**RE: NW K Thru 8 Prototype School
9601 Tierra Pintada Blvd NW
Permanent C.O. - Accepted
Engineer's Certification Dated 10/01/18
Engineer's Stamp Date: 11/17/17
Hydrology File: J08D003A**

DRAINAGE AND TRANSPORTATION INFORMATION SHEET (REV 6/2018)

ENGINEERS - CERTIFICATION TEMPORARY C.O.

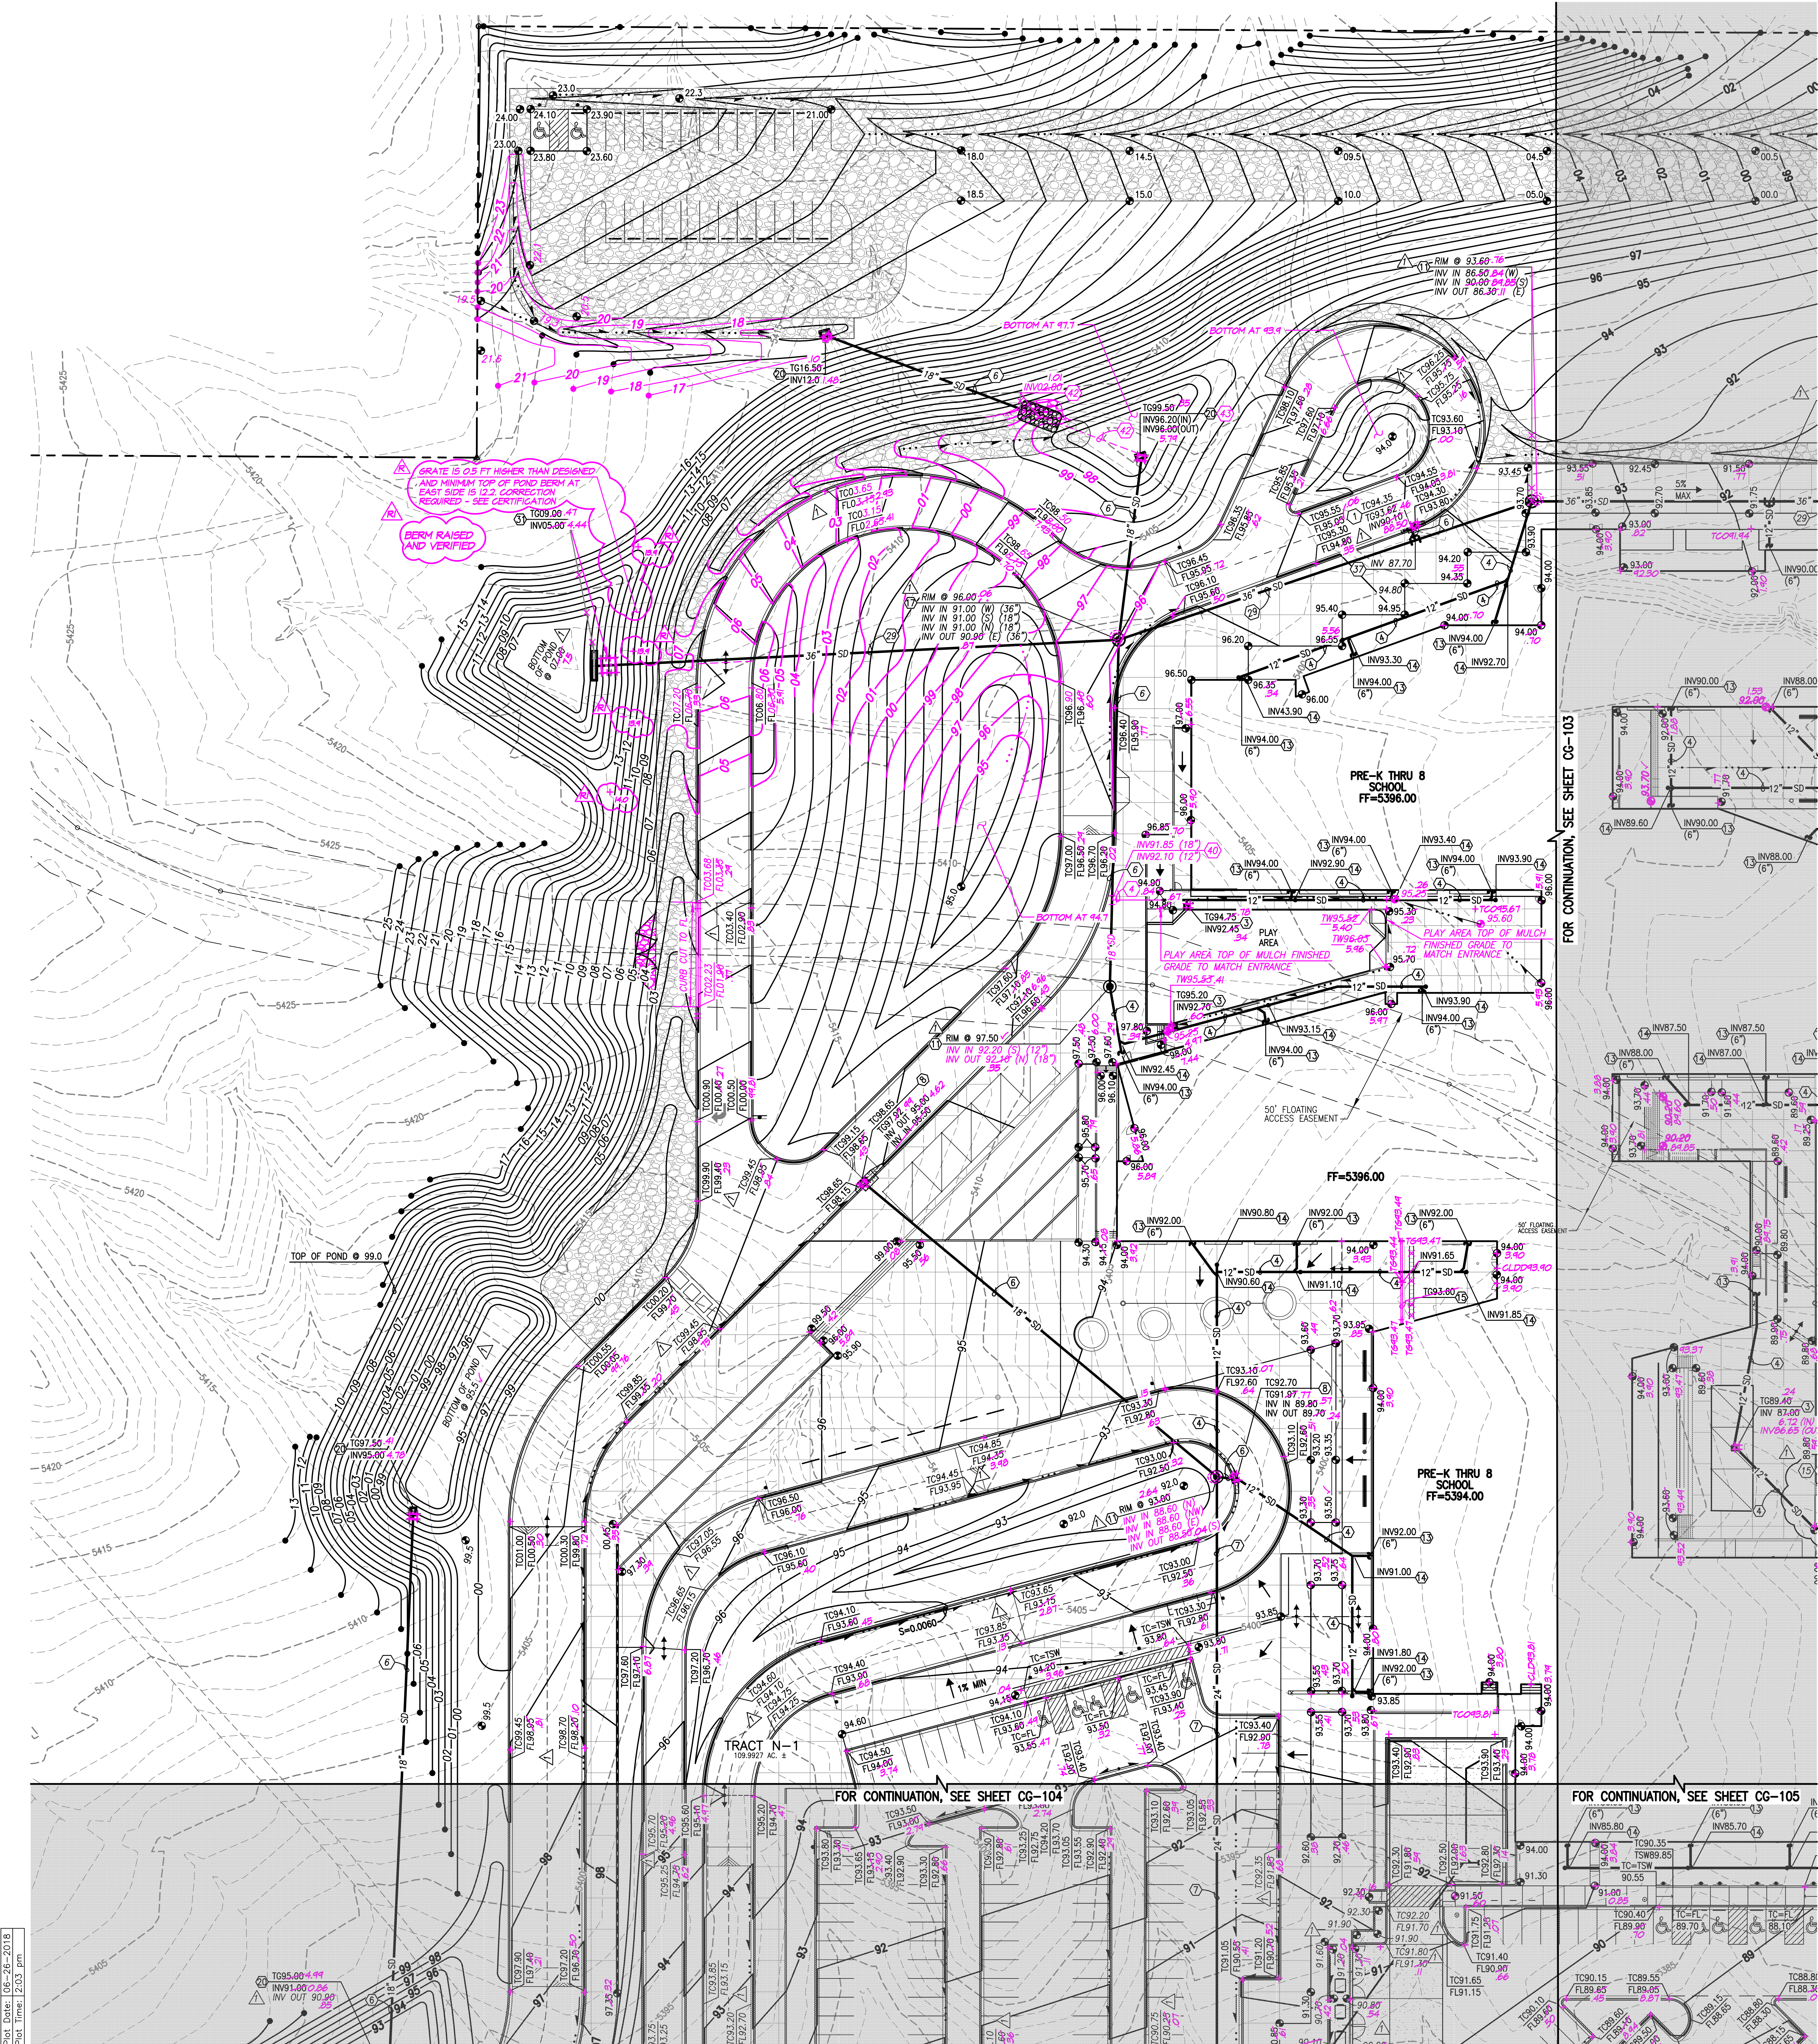
THE FOLLOWING DEVIATIONS WERE NOTED AND WILL REQUIRE CORRECTION PRIOR TO ENGINEER'S FINAL CERTIFICATION FOR PERMANENT CERTIFICATE OF OCCUPANCY:

- THE STORM INLET IN THE NORTHWEST SEDIMENT/FLOW COLLECTION POND (AP-1) WAS CONSTRUCTED 0.5 FT HIGHER THAN PLAN, AND THE POND DOES NOT HAVE THE REQUIRED TOP OF BERM/CONTAINMENT ELEVATIONS ON THE EAST SIDE TO CONTAIN A 100-YEAR EVENT WITH THE DESIGNED SAFETY MARGIN/FREEDBOARD. AS DEMONSTRATED BY THE ATTACHED ANALYSIS, THE POND WILL BE ABLE TO ACCOMMODATE THE REQUIRED FLOW RATE WITH 0.2 FT OF FREEDBOARD (CONSERVATIVELY INCLUDING A 50% CLOSING FACTOR) IN THE CURRENT CONDITION AND DOES NOT PRESENT AN IMMINENT HAZARD THAT WOULD PRECLUDE TEMPORARY CERTIFICATION. THE FREEDBOARD CONDITION AND/OR THE GRADE ELEVATION MUST BE CORRECTED AND VERIFIED PRIOR TO FINAL CERTIFICATION FOR PERMANENT CERTIFICATE OF OCCUPANCY. SEE SHEET CG-103 AND ATTACHED SUPPORTING INFORMATION.

- THE MAIN DETENTION POND LOCATED AT THE EAST END OF THE SITE DOES NOT HAVE THE REQUIRED TOP OF BERM/CONTAINMENT ELEVATIONS ON THE EAST SIDE TO CONTAIN THE FUTURE CONDITIONS 100-YEAR EVENT WITH THE DESIGNED SAFETY MARGIN/FREEDBOARD. AS DEMONSTRATED BY THE ATTACHED ANALYSIS, THE POND WILL BE ABLE TO ACCOMMODATE THE REQUIRED FLOW RATE WITH 1.4 FT OF FREEDBOARD (CONSERVATIVELY INCLUDING A 50% CLOSING FACTOR) IN THE CURRENT (INTERIM) CONDITION AND DOES NOT PRESENT AN IMMINENT HAZARD THAT WOULD PRECLUDE TEMPORARY CERTIFICATION. THE FREEDBOARD CONDITION AND/OR THE GRADE ELEVATION MUST BE CORRECTED AND VERIFIED PRIOR TO FINAL CERTIFICATION FOR PERMANENT CERTIFICATE OF OCCUPANCY. SEE SHEET CG-103 AND ATTACHED SUPPORTING INFORMATION.

- THE NEW GRADED LID MANHOLE LOCATED AT THE POND OUTFALL STORM DRAIN CONNECTION TO THE PRE-EXISTING OUTLET PIPE WAS CONSTRUCTED 1 FT BELOW THE DESIGN ELEVATION. THE INTENT WAS TO HAVE THE RIM SET 1 FT ABOVE GRADE TO ALLOW FOR SEDIMENT COLLECTION AROUND THE MANHOLE WITHOUT ALLOWING SEDIMENT TO ENTER THE GRADE. IN LIEU OF RAISING THE RIM, THE SURROUNDING GRADE SHALL BE CUT DOWN TO MEET THE INTENT. THIS CONDITION MUST BE CORRECTED AND VERIFIED PRIOR TO FINAL CERTIFICATION FOR PERMANENT CERTIFICATE OF OCCUPANCY. SEE SHEET CG-103.

- THE EAST PLAY FIELD CONSTRUCTION THAT WAS IN PROGRESS DURING PREVIOUS CERTIFICATION HAS BEEN COMPLETED.
- THE STORM INLET IN THE SOUTHWEST SEDIMENT/FLOW COLLECTION POND WAS CONSTRUCTED 1.1 FT HIGHER THAN PLAN (IT SHOULD BE NOTED THAT A 0.5 FT INCREASE WAS AUTHORIZED DURING CONSTRUCTION), AND THE POND DOES NOT HAVE THE REQUIRED TOP OF BERM ELEVATIONS ON THE EAST SIDE TO CONTAIN A 100-YEAR EVENT. THE POND WILL ACCOMMODATE THE REQUIRED FLOW RATE WITH 0.2 FT OF FREEDBOARD AND A CLOSING FACTOR OF 50%, AND DOES NOT PRESENT AN IMMINENT HAZARD THAT WOULD PRECLUDE TEMPORARY CERTIFICATION. THIS CONDITION MUST BE CORRECTED AND VERIFIED PRIOR TO FINAL CERTIFICATION FOR PERMANENT CERTIFICATE OF OCCUPANCY. SEE SHEET CG-104 AND ATTACHED SUPPORTING INFORMATION.

UPON CORRECTION OF THE PRECEDING ITEMS, A FOLLOW UP VERIFICATION AND CERTIFICATION WILL BE PROVIDED FOR PERMANENT CERTIFICATE OF OCCUPANCY.
